# **Change Order Third Party Funding Notification Sheet**

DESCRIPTION: 102-IN DRILLED SHAFT DOWEL PACKAGE DELAY

REASON: 1B - 1B-INCORRECT PS&E (CONSULTANT DESIGN)

The subject change order adds revised plan sheets 642 to 648, 650, and 651 to the Contract.

SHEET 1	OF 2			
FED.RD. DIV.NO.		PROJECT NO.		SHEET NO.
6				642
STATE	DIST.		COUNTY	
TEXAS	HOU	F	ORT BEND	
CONT.	SECT.	JOB	HIG	HWAY NO.
3510	04	019,ETC.	S	н 99

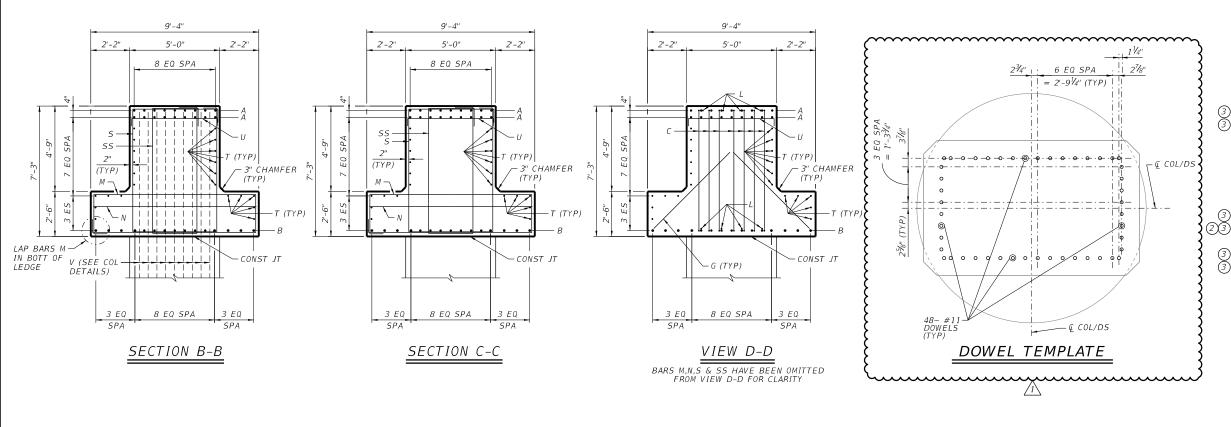
1	8/10/23	MODIFY DOWEL LAP LENGTH.	YFS
Ī				
ľ	NO.	DATE	REVISION	APPROV

JILET Z OT Z						
FED.RD. DIV.NO.		SHEET NO.					
6		643					
STATE	DIST.						
TEXAS	HOU	F					
CONT.	SECT.	JOB	HIG	GHWAY NO.			
3510	04	019,ETC.	SH 99

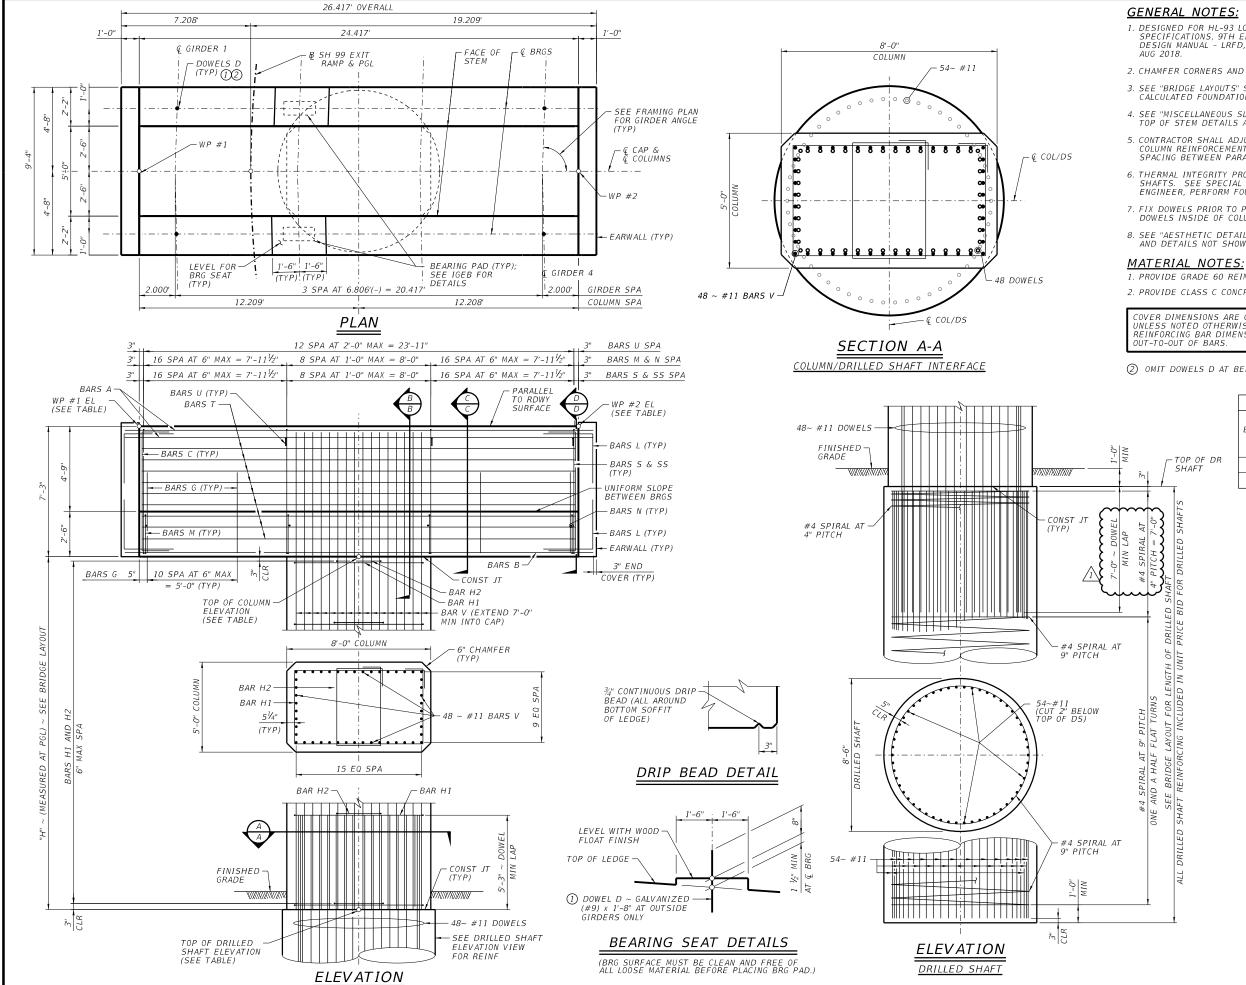
8/10/2023 MODIFY DOWEL SPACING.

SHEET I OF 2						
FED.RD. DIV.NO.		PROJECT NO.				
6				644		
STATE	DIST. COUNTY					
TEXAS	HOU	HOU FORT BEND				
CONT.	SECT.	JOB	HWAY NO.			
3510	0.4	019 FTC	ς	н оо

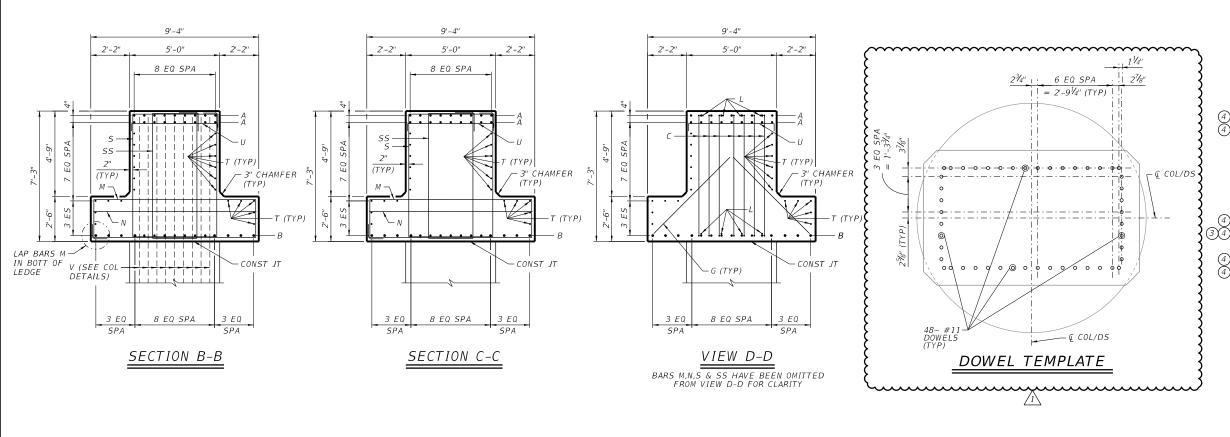
2 OMIT DOWELS D AT BENT 4.

1	8/10/23	MODIFY DOWEL LAP LENGTH.	YFS
NO.	DATE	REVISION	APPROV

SHEEL Z OF Z					
	FED.RD. DIV.NO.		PROJECT NO.	SHEET NO.	
	6			645	
	STATE	DIST.			
	TEXAS	HOU	FORT BEND		
	CONT.	SECT.	JOB	HIG	HWAY NO.
	3510	04	019,ETC.	S	Н 99

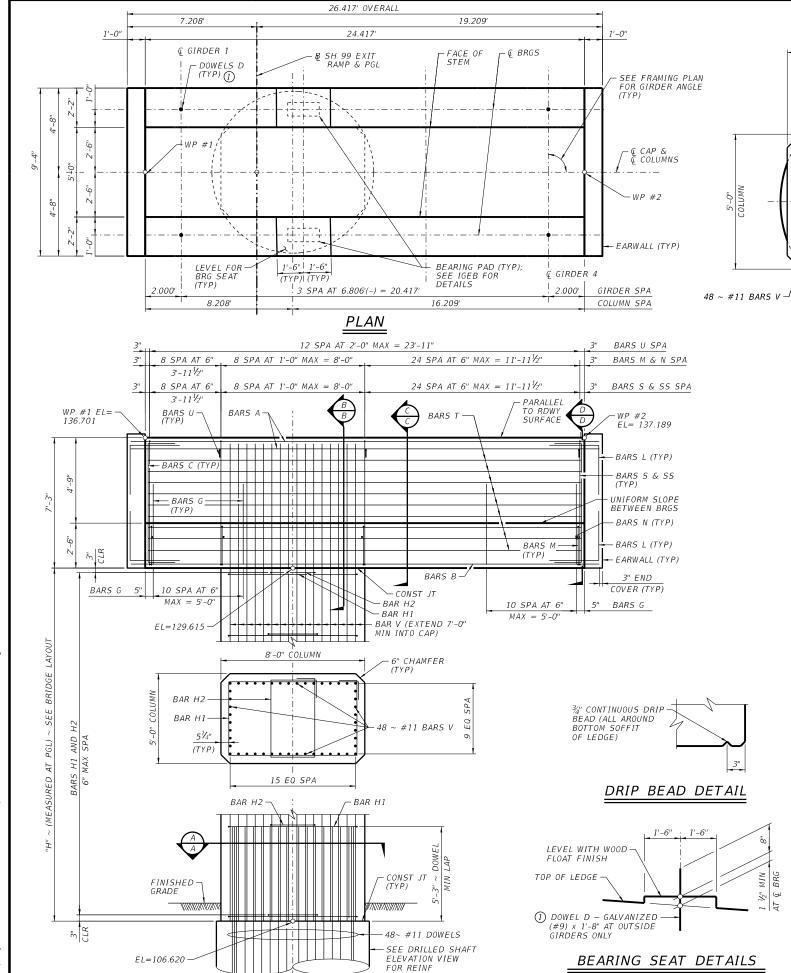
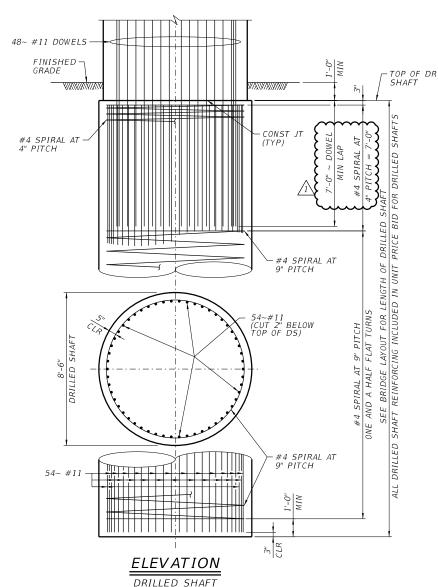
0/10/2025					
1	8/10/23	MODIFY DOWEL SPACING.	YFS		
NO.	DATE	REVISION	APPROV.

SHEET 1 OF 2 646 CONT. HIGHWAY NO. SECT. 04 019,ETC SH 99

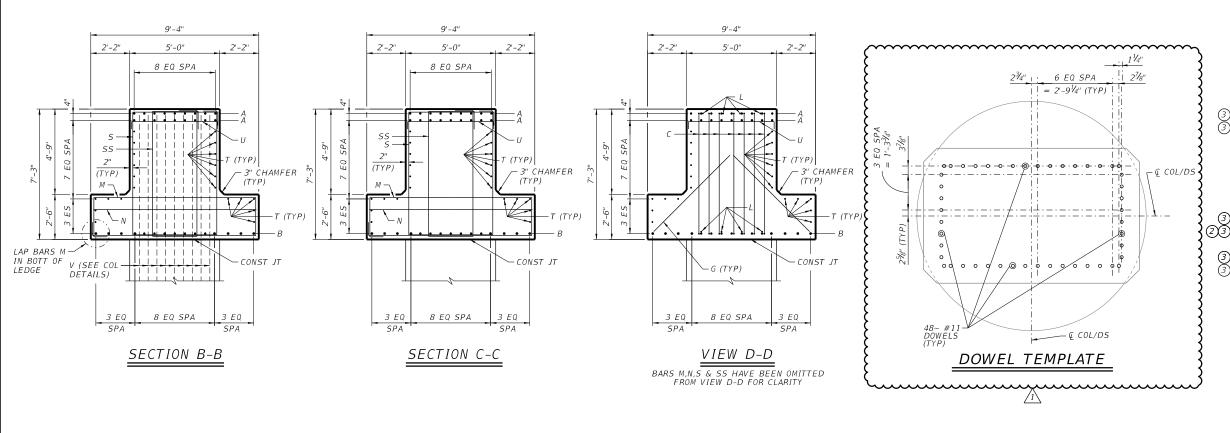
8/10/2023 1 8/10/23 YFS MODIFY DOWEL LAP LENGTH. NO. DATE REVISION APPRO

SHEET 2 OF 2					
	FED.RD. DIV.NO.		PROJECT NO.	SHEET NO.	
	6				647
	STATE	DIST.		COUNTY	
	TEXAS	HOU	F	ORT BEND	
	CONT.	SECT.	JOB	HIG	HWAY NO.
	3510	04	019,ETC.	S	н 99

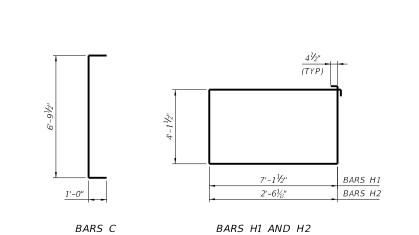
07 107 2023					
1	8/10/23	MODIFY DOWEL SPACING.	YFS		
NO.	DATE	REVISION	APPROV.

648 HIGHWAY NO. SECT. 04 019,ETC SH 99

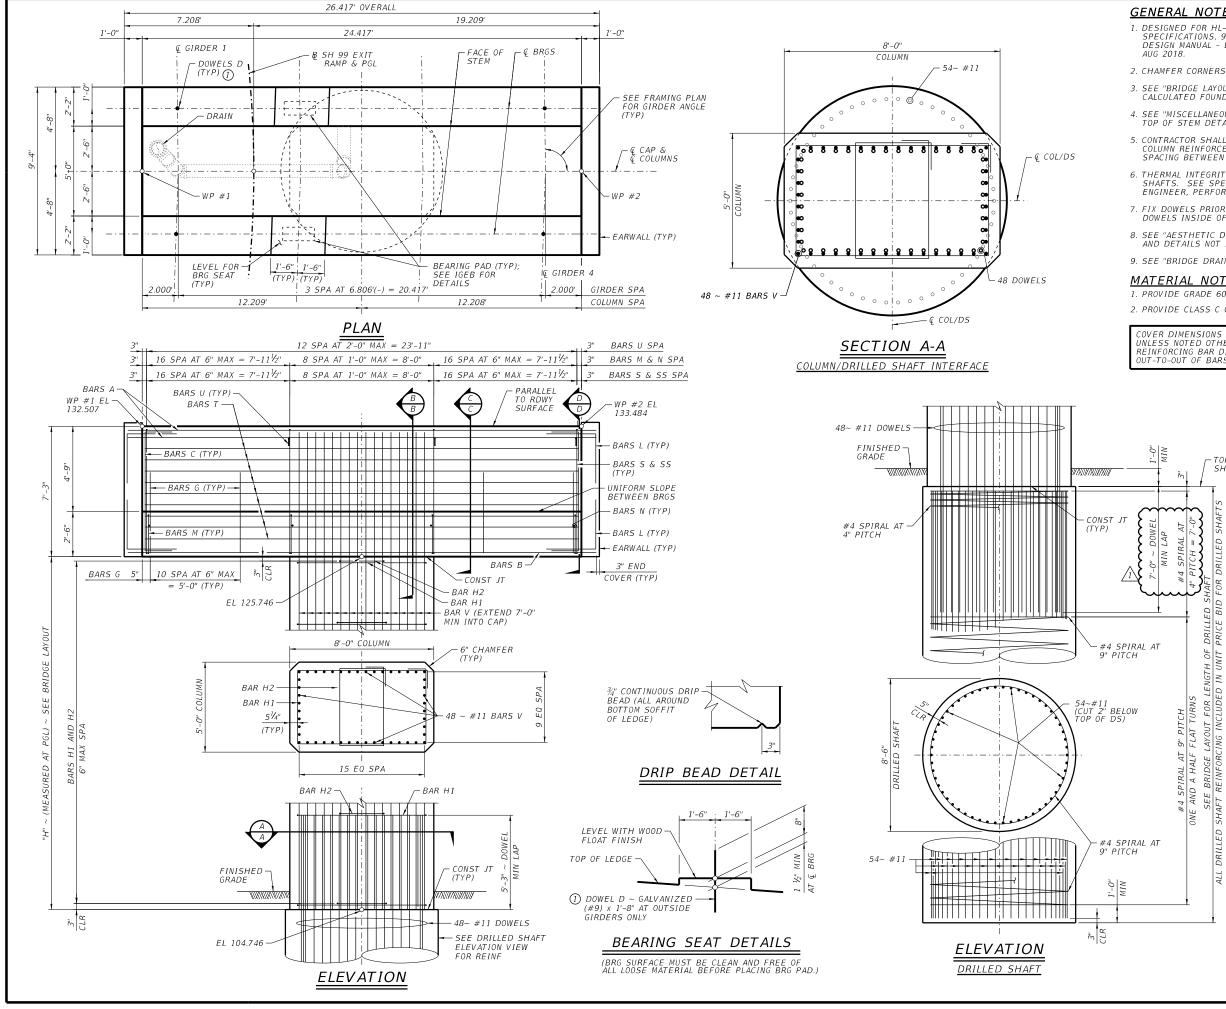
1	8/10/23	MODIFY DOWEL LAP LENGTH AND NUMBER.	JFT
NO.	DATE	REVISION	APPRO\
